DRAINAGE PLAN

KAMEHAMEHA HIGHWAY REHABILITATION
WAIHAU STREET to H-2 INTERCHANGE
FEDERAL AID PROJECT NO. NH-099-1(24)

SHEET No. H1 OF 13 SHEETS

"AS-BUILT"

SHEET No. H2 OF 13 SHEETS

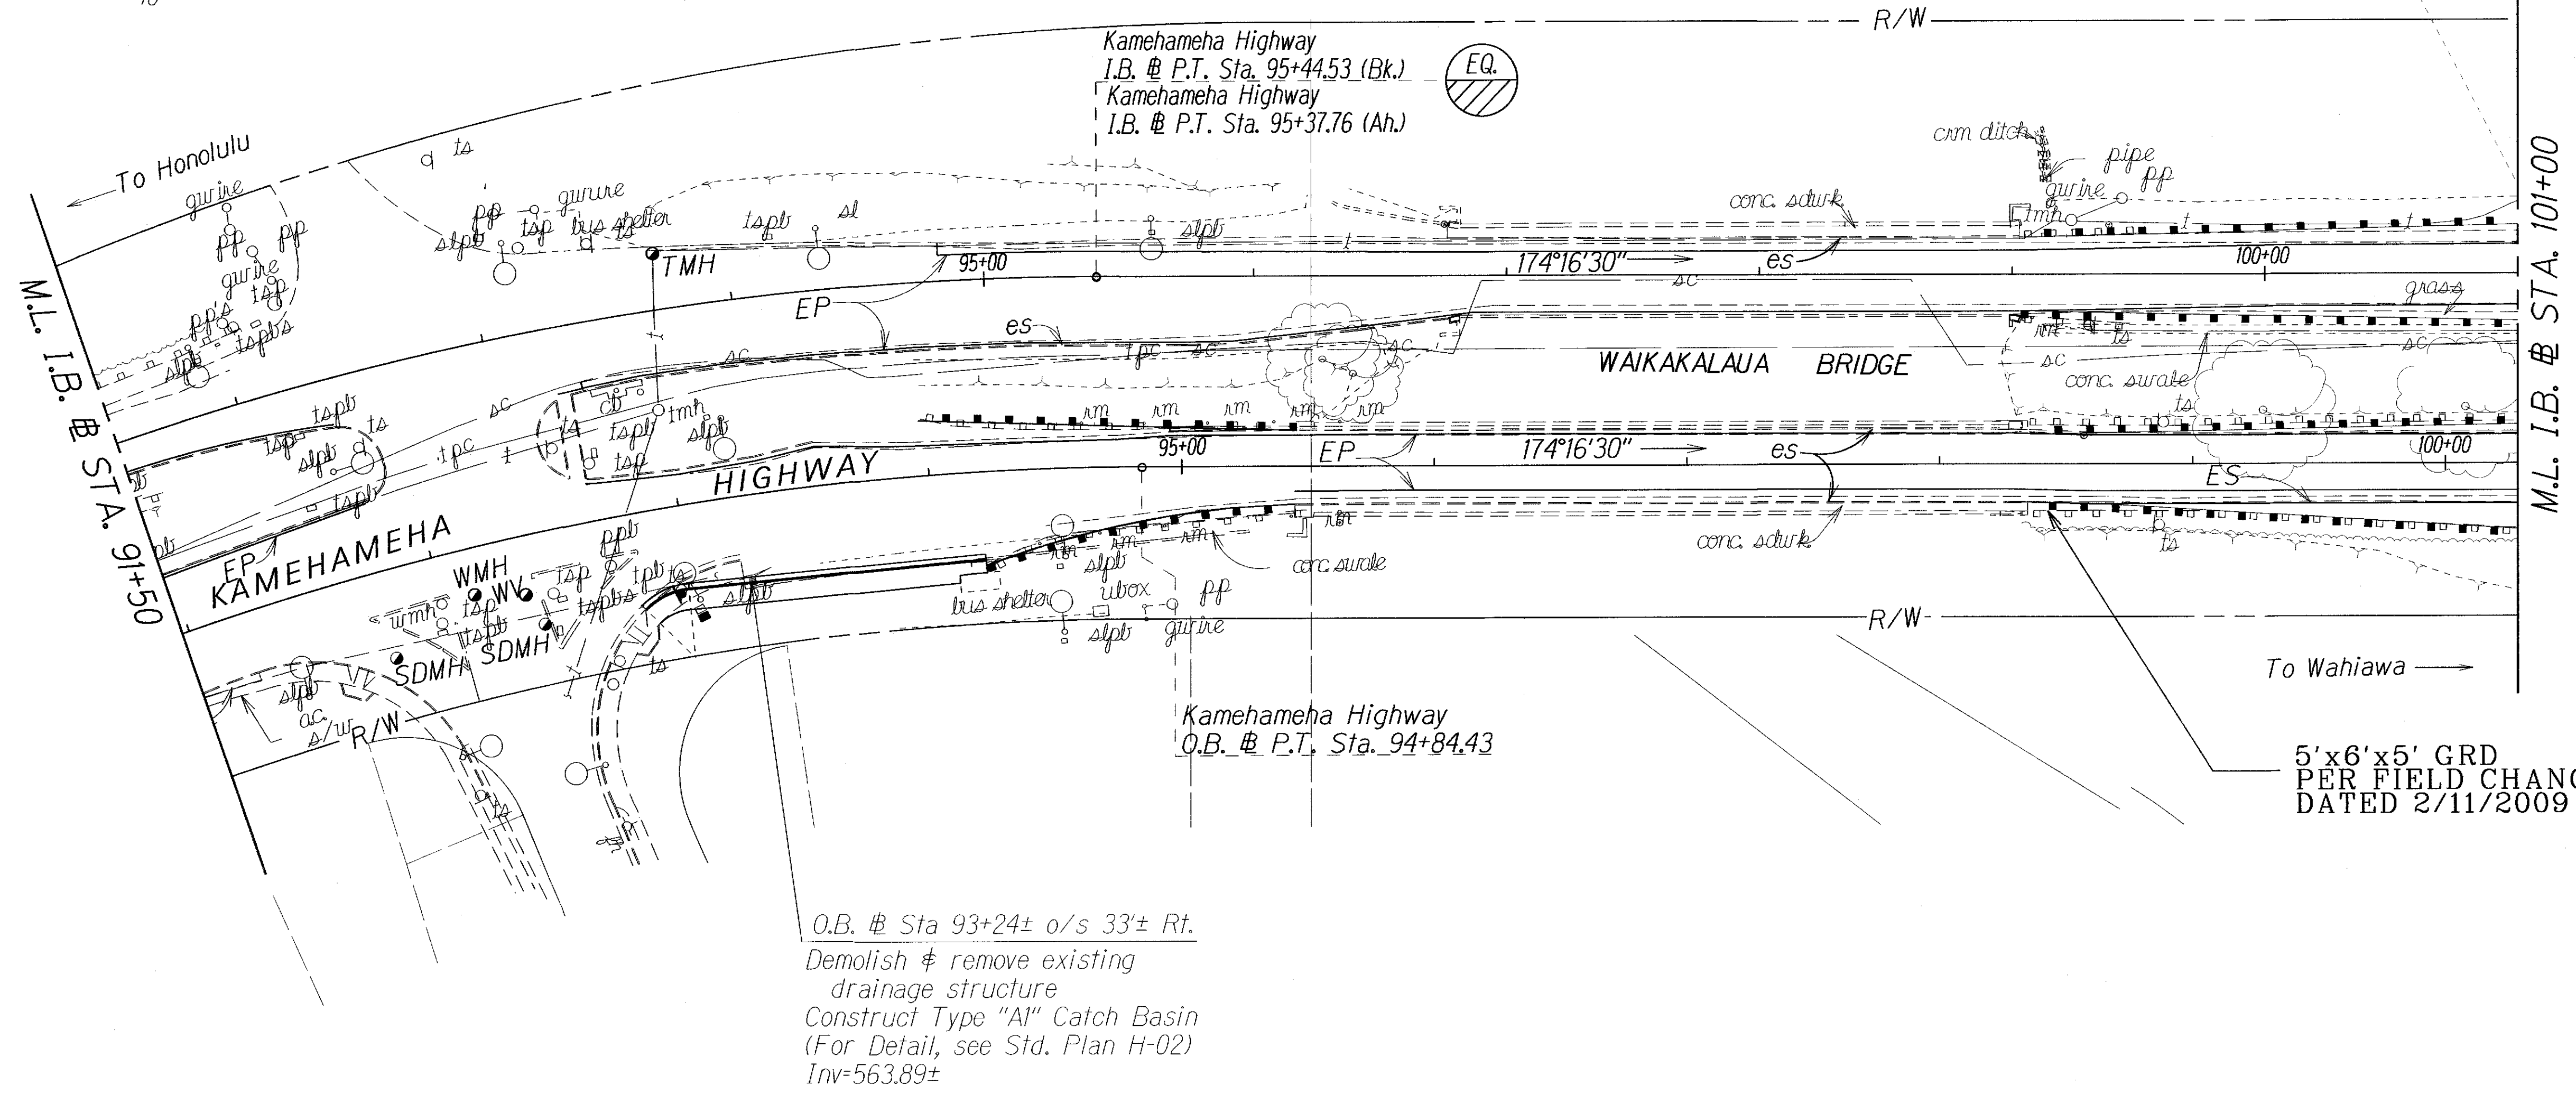
5'x6'x5' GRD
PER FIELD CHANGE NO.13
DATED 2/11/2009

SHEET No. H5 OF 13 SHEETS

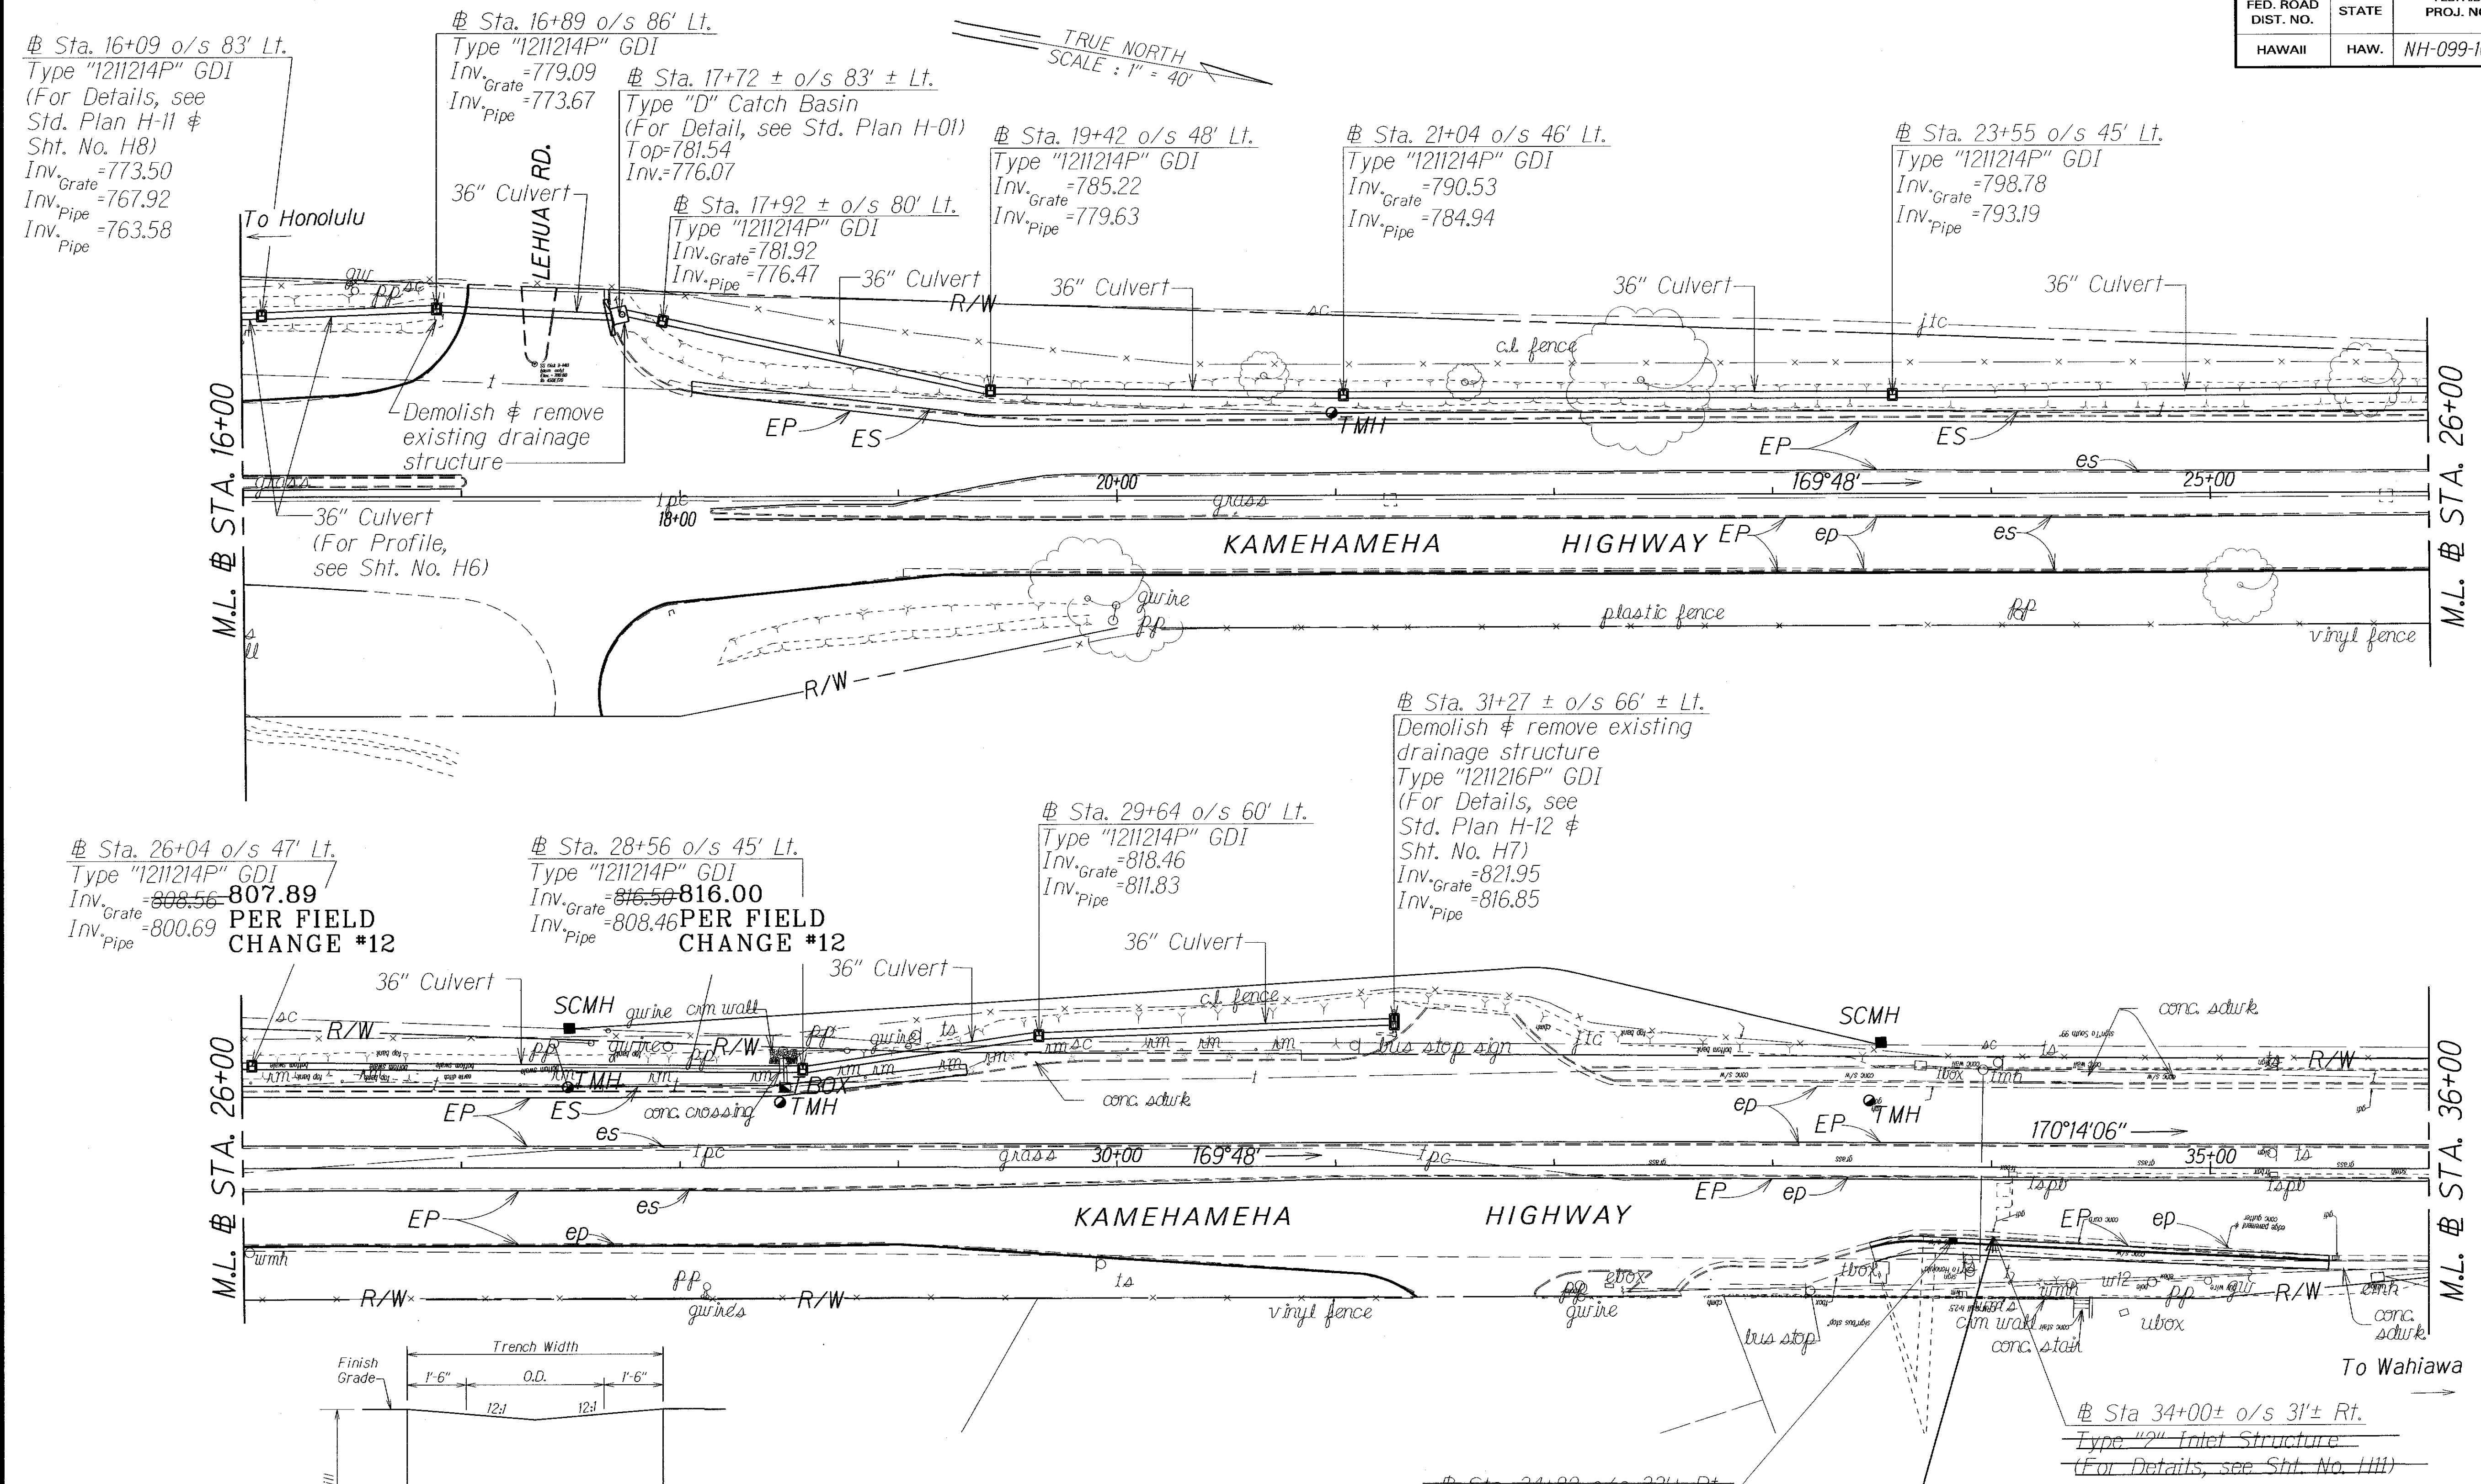
TYPE D1 CATCH BASIN
5.00 TO 5.99 FT
PER CONTRACT
CHANGE ORDER #09

PLANNED STRUCTURE
DELETED
PER #0020
